LUSCOMBE AIRPLANE CORPORATION  
West Trenton, New Jersey

-----  
ENGINEERING BULLETIN NO. 9

December 29, 1939

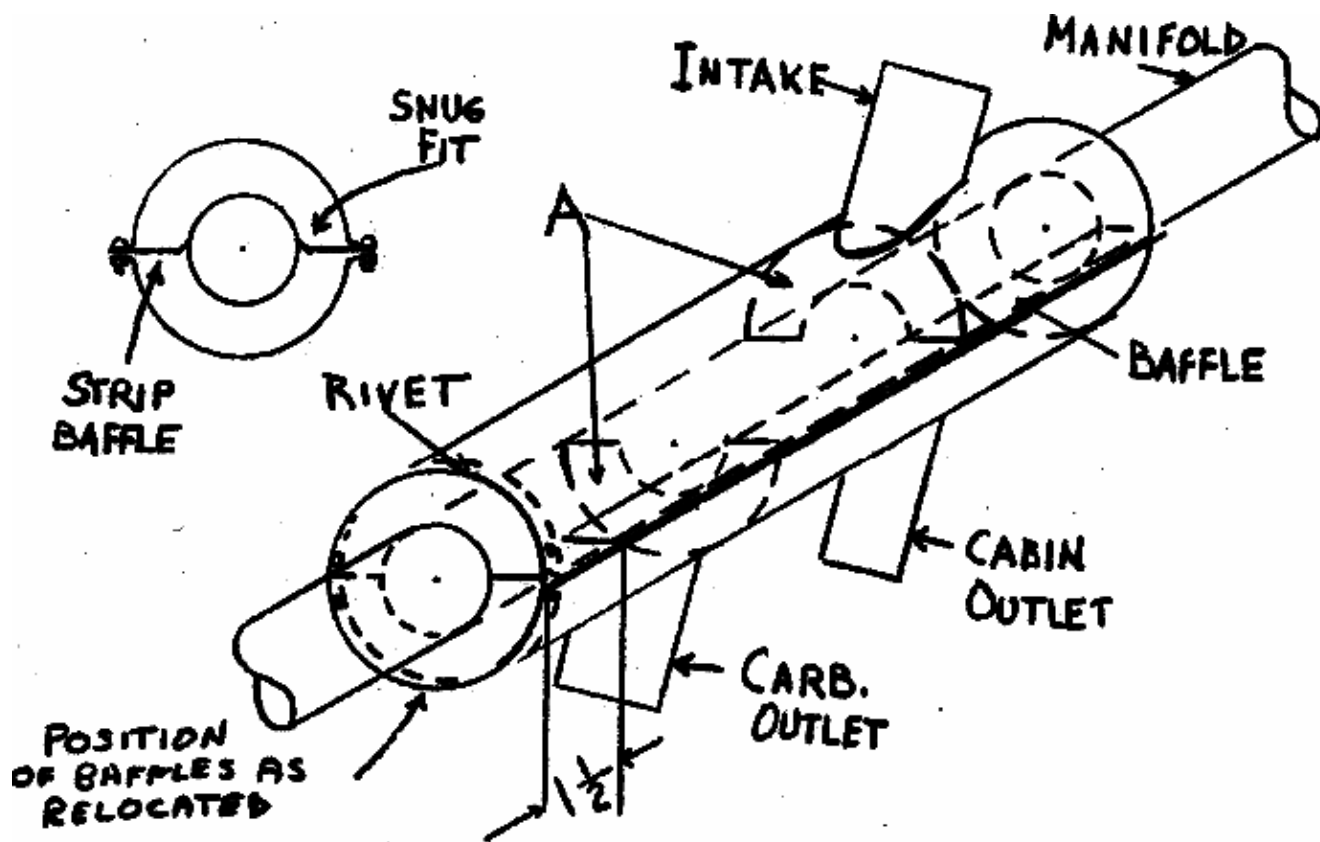
The heat output of the heaters provided with our single opening exhaust system can be increased by incorporating changes as follows:

1. Remove the ring shaped baffles from both halves of the muff. (Marked "A" on sketch.)
2. Relocate ring shaped baffles at right and so as to close off air flow.
3. Install metal strip baffle (furnished) between halves of muff as shown in sketch.
